Application for Works Approval Amendment

| Works Approval Number | W6641/2022/1 |
| Works Approval Holder | Iluka Rare Earths Pty Ltd |
| Premises | <p>Eneabba Rare Earths Refinery Part of Mining Lease M267SA ENEABBA WA 6518</p> <p>As defined by the Premises maps attached to the Revised Works Approval</p> |

Figure 1: Revised layout of the premises showing the new location of the Brine Bleed Evaporation Pond, Stormwater Dam and Sulfate Dam and associated pipelines.

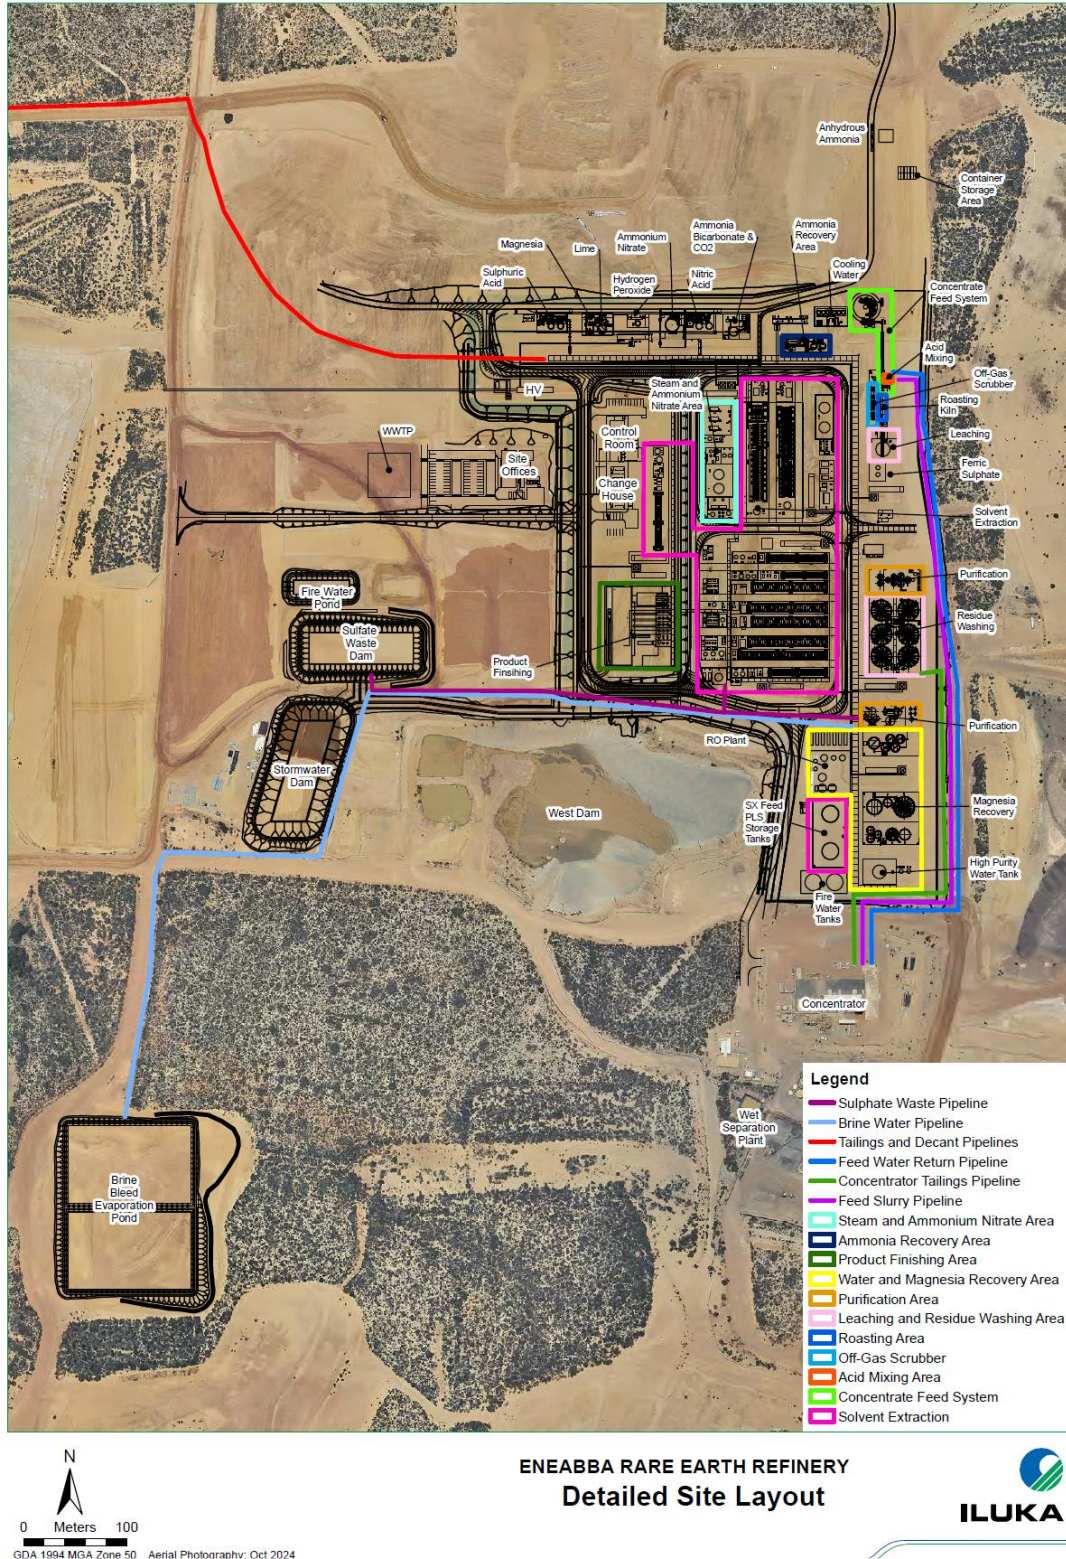
The Works Approval Holder proposes to relocate the Brine Bleed Evaporation Pond, Stormwater Dam and Sulfate Dam from north of the refinery to the east and south of the refinery area. Pipeline routes to the Brine Bleed Evaporation Pond, tailings storage facility (TSF) and the Concentrator Plant Feed pipeline are also planned to be relocated.

No changes to the design or controls associated with the ponds, dams or pipelines are proposed

by the Works Approval Holder and therefore the changes are not expected to alter the risk profile of these facilities. As such, risks associated with the process water storage ponds and associated transfer pipelines has not been reassessed.

Figure 2: Alternative design of surface water diversion structures.

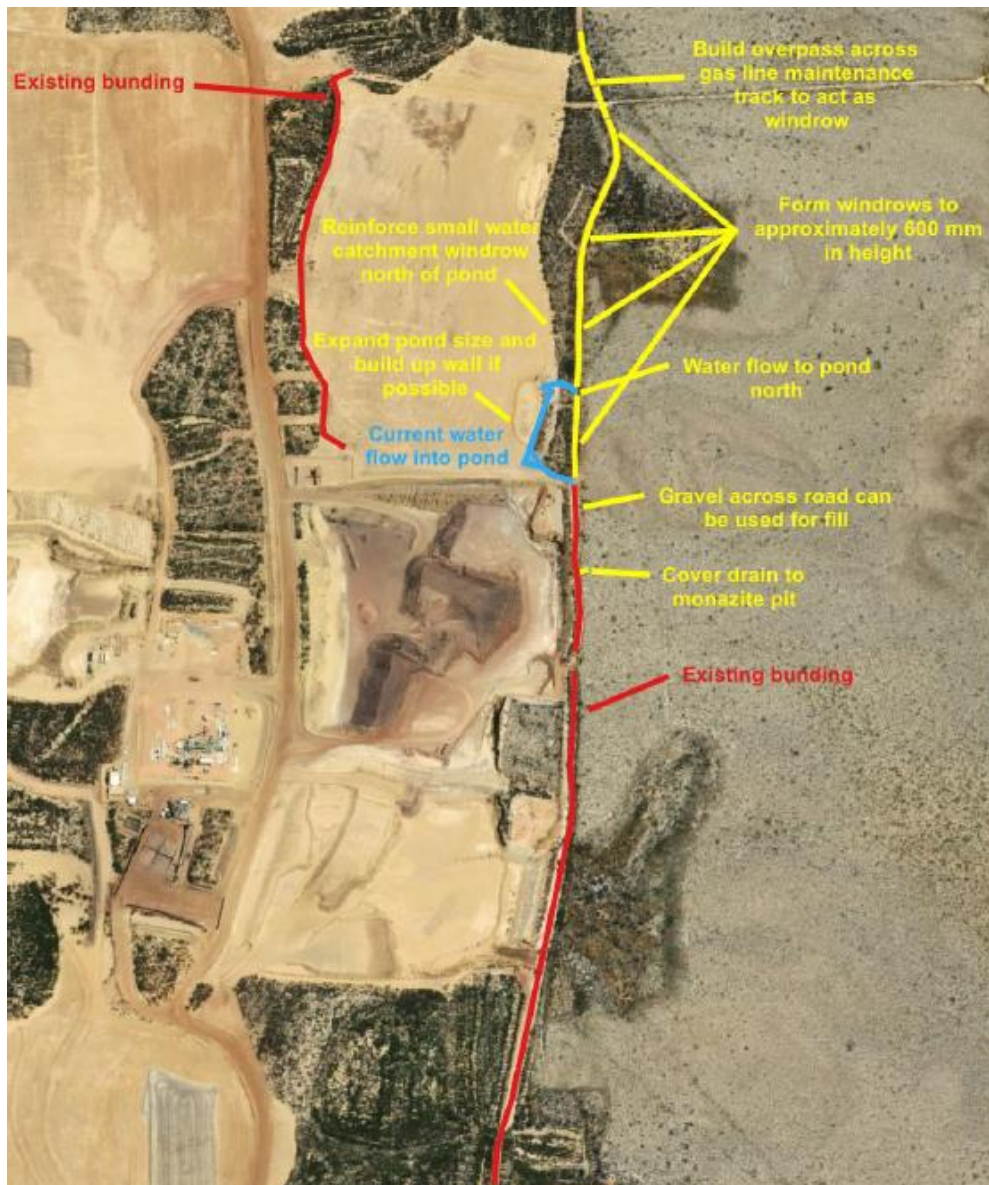
The Works Approval Holder has advised that the 1km drain is no longer proposed, and instead, existing surface water diversion bunds will be utilised to divert runoff towards the South Depression. In addition to existing diversion bunds, extra bunding has been installed to support the surface water diversion design (refer to Figure 2 below).

Given that the initial design is no longer required, the Works Approval Holder is requesting that the relevant conditions regarding stormwater infrastructure be removed from the works approval.

In support of this amendment, the Works Approval Holder submitted updated hydraulic modelling (Water Technology 2024) which reviewed the revised stormwater diversion design. Modelling results suggest that the existing diversion structures will successfully divert flows away from the North Mozanite Pit into a small water dam to the south, and that all southern water flows will be diverted towards the South Depression.

The delegated officer considers that the revised design of the stormwater diversion infrastructure meets the intent of the original design and therefore does not alter the risk profile of the premises. As such, risks associated with stormwater have not been reassessed and conditions updated accordingly.

Figure 3: Initial stormwater diversion bund design (Water Technology 2022).

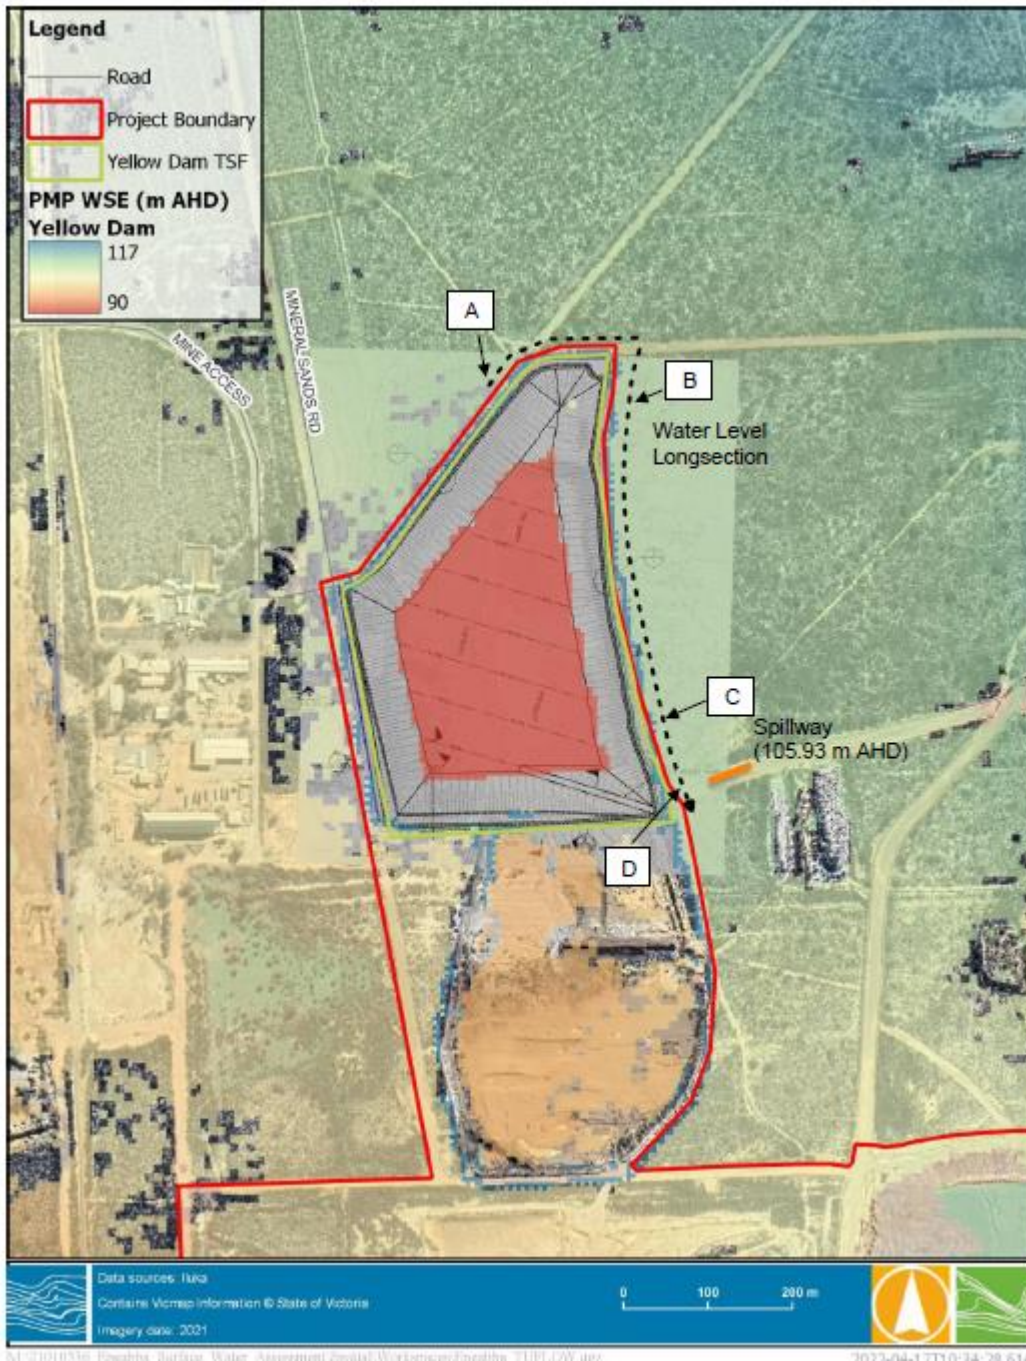
Stormwater protections are also proposed around the Yellow Dam TSF to protect the integrity of the storage facility. The Works Approval Holder commissioned a surface water assessment of the impact of a 1% Annual Exceedance Probability (AEP) and Probably Maximum Flood event on the Yellow Dam TSF. This involved hydraulic modelling (Water Technology 2022) of the TSF and surrounding area to inform the design of bunding around the facility to prevent stormwater ingress. The assessment concluded that construction of diversion bunds around the Yellow Dam TSF are required to prevent stormwater entering the facility and recommended a diversion bund on the eastern side of the TSF (Figure 3). A spillway was also proposed to allow drainage of surface flows to the south. As a result, the existing works approval requires that earthen bund wall/s must be constructed around the Yellow Dam TSF to keep stormwater from contacting embankment walls in the event of a 1% AEP flood level.

The stormwater diversion design has since been revised and further hydraulic modelling undertaken to confirm that the intent of the works approval condition will be achieved (Water Technology 2024a). The revised design includes two diversion bunds upstream of the TSF; north-south and east-west bunds located along existing roads (Figure 4). The updated hydraulic modelling indicates that the proposed diversion bunds will sufficiently prevent external runoff entering the TSF under the modelled 1% AEP (1 in 100 year) and 0.1% AEP (1 in 1,000 year) events.

Given that diversion bunds are located upstream of the TSF, modelling indicated potential for water from the small catchment between the downstream side of the flow protection bunds and upstream of the TSF to accumulate along the eastern embankment, particularly during a 0.1% AEP (1 in 1,000 year) event. To address this, flow will be diverted away from the TSF via an engineering road-spillway located to the south.

Following consideration of a number of options, the Works Approval Holder has also elected to install an additional measure to manage ponded water on the eastern side of the TSF. The haul road will be lowered and a small swale inserted to drain water to the south-east. The Works Approval Holder also proposes install a rip-rap layer along the downstream side of the TSF eastern embankment as a flood erosion protection measure.

Figure 5: Groundwater monitoring bore locations

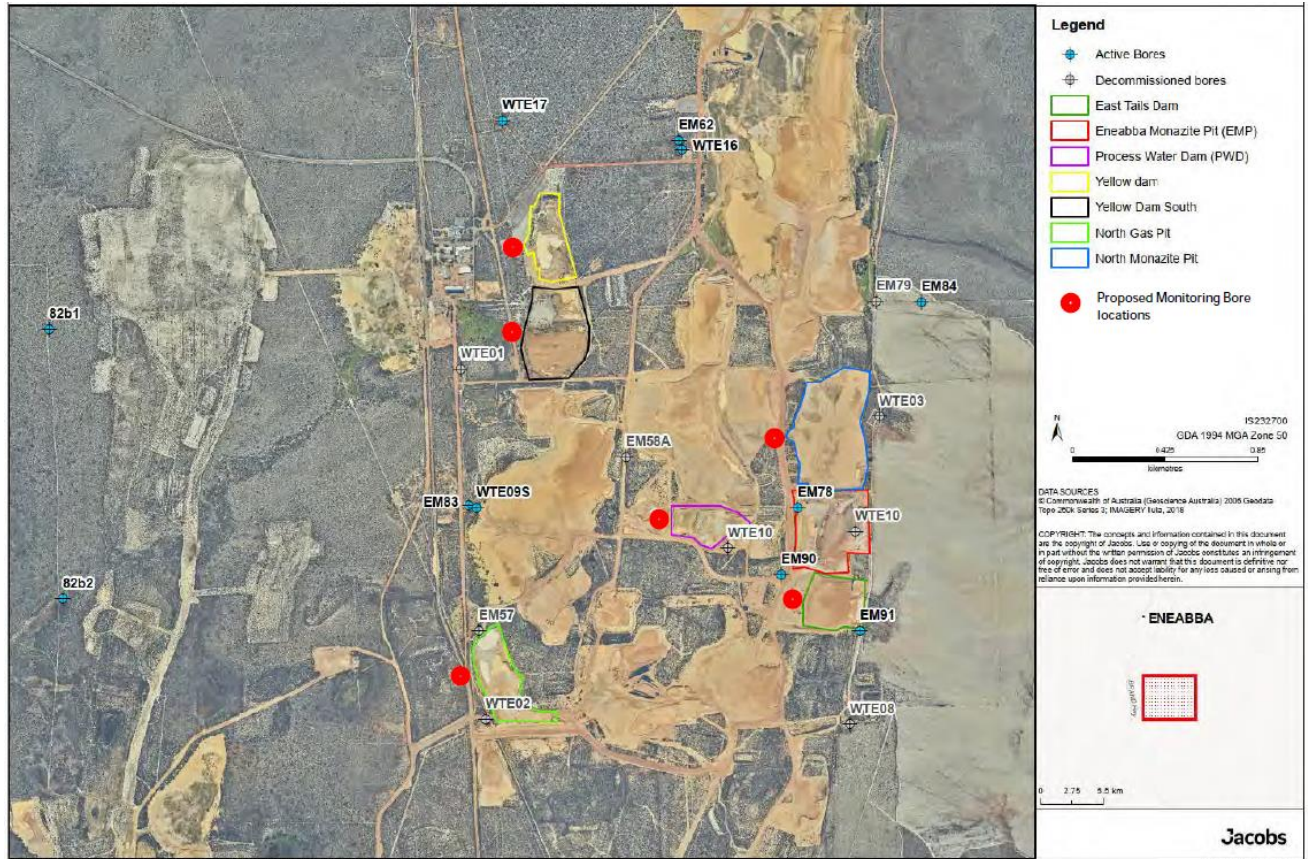
Of the contaminants present in the tailings waste stream, lead, cadmium, aluminium and uranium were measured as being below limits of reporting for the groundwater analysis undertaken at the monitoring locations identified in Figure 5.

Investigations informing the seepage modelling identified that groundwater flows in a west to north-west direction, away from the Eneabba Water Reserve.

Figure 6: Predicted maximum 1-hour NH₃ concentration (µg/m³)

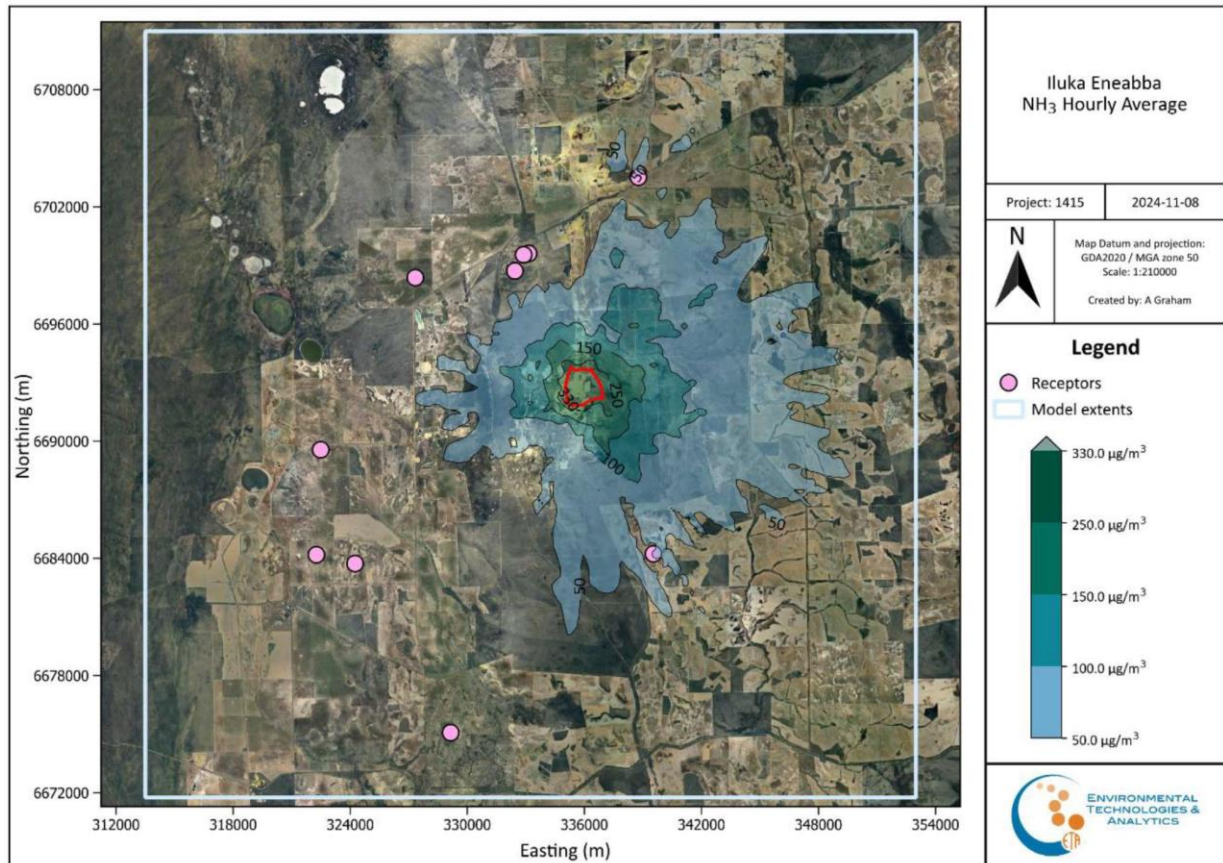
Despite the additional sources of ammonia, the maximum predicted GLC concentrations of ammonia are expected to be well below the assessment criteria at sensitive receptors (<16%). However, ammonia concentrations are predicted to exceed the guideline value for human health provided in the *Draft Guideline: Air Emissions* (DWER 2019) in areas directly east of the premises (Figure 6). While it is acknowledged that the assessment criteria applies to all areas outside of the premises (unlike the assessment criteria for NO_x, SO₂ and particulates which only apply to sensitive receptors locations), the delegated officer notes that there are no receptors

present in this area. Considering the low spatial extent of the exceedance and lack of receptors, the risk of elevated ammonia emissions impacting on receptors is considered to be low.

A technical review of the modelling identified some inconsistencies with the *Air Quality Modelling Guidance Notes* (DoE 2006), however, since the predicted GLCs for pollutants are well below the relevant guideline values, it was determined that these discrepancies are unlikely to significantly affect the overall outcome of the assessment.
